## Interface Resistor Upgrade – AccuDry3 1417

A 100 Ohm resistor on the interface PCB has been found to fail. After it fails the Accudry constantly shows “door open”.

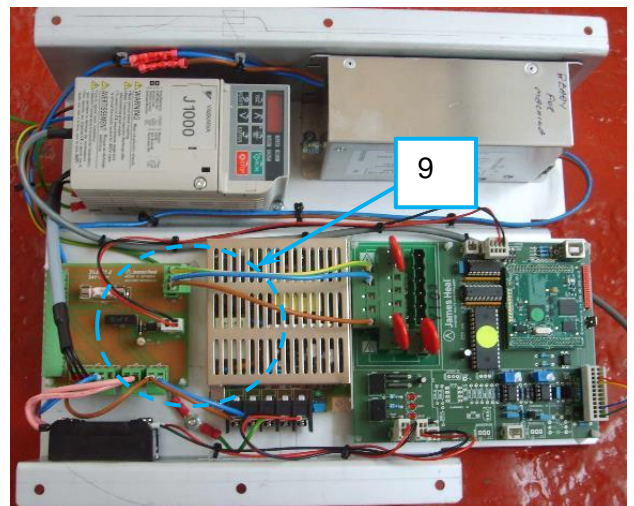
9. Remove the interface PCB from the electrical chassis.

10. Desolder the 100 Ohm resistor from the Interface PCB and solder a 2 Watt 100 Ohm resistor in its place.

To resolve the issue the 100 Ohm resistor (1/8 W) should be replaced with a higher power rated version (2W).
